CITY PLANNING COMMISSION

- APPLICATION:
1. Environmental Determination
 2. Lot Line Adjustment to combine four parcels into one on .29 acres located in the C-2 zone

LOCATION: 1529-21st Street

PROPOSAL: The applicant is requesting the necessary entitlement to combine four parcels into one for an office conversion and retail center.

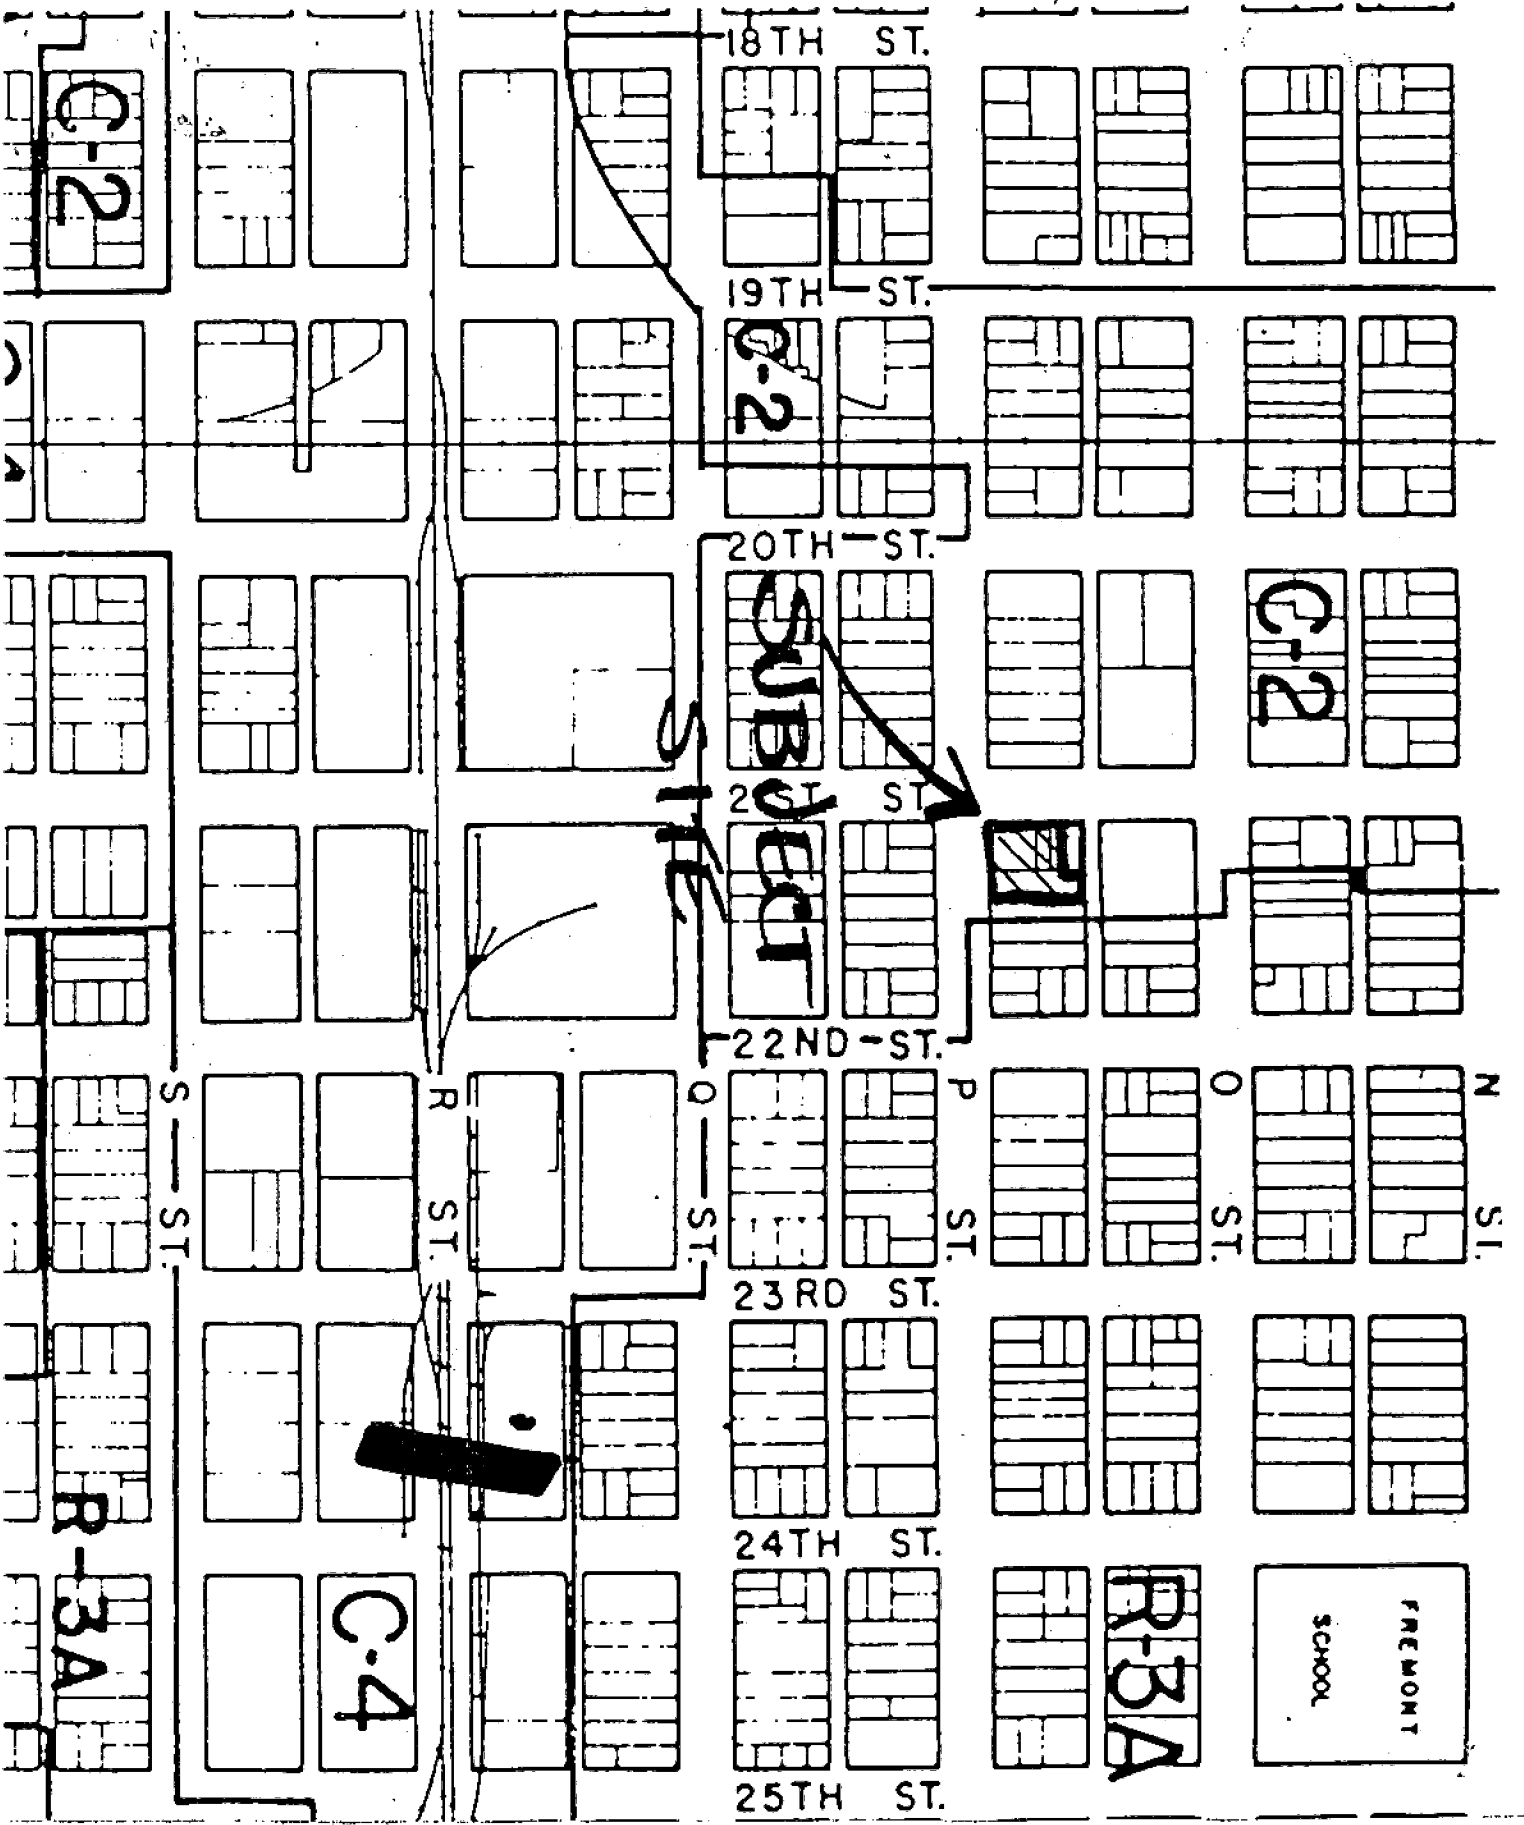
One of the parking areas is semi-improved; however, concrete wheel stops and landscaping are not provided on the site. The parking area at the rear of the building is unimproved and will require grading, paving and striping. This parking fronting on 21st Street will also be subject to the 50% shading requirement since it is a new improvement being installed to provide parking for the office conversion (see Exhibit C).

2. The applicant indicates that there are 27 parking spaces available on the site; however, the parallel spaces will have to be eliminated since they are not permitted by the Zoning Ordinance.

In addition, some parking spaces on the north lot may be lost due to shading requirements.

4. There are two existing planters at the 'P' Street entrance to the parking area. These planters do not contain landscaping and it is staff's recommendation that landscaping (shrubs and ground cover) be provided in these planters. Staff also recommends that a planter be constructed at the alley entrance to provide shading and add relief to the monotony of the large paved areas (see Exhibit C).

5. There is a cyclone fence separating the north parking area from 21st Street. It is staff's recommendation that a planter with raised curb, shade trees and low landscaping be provided along this area (see Exhibit C).
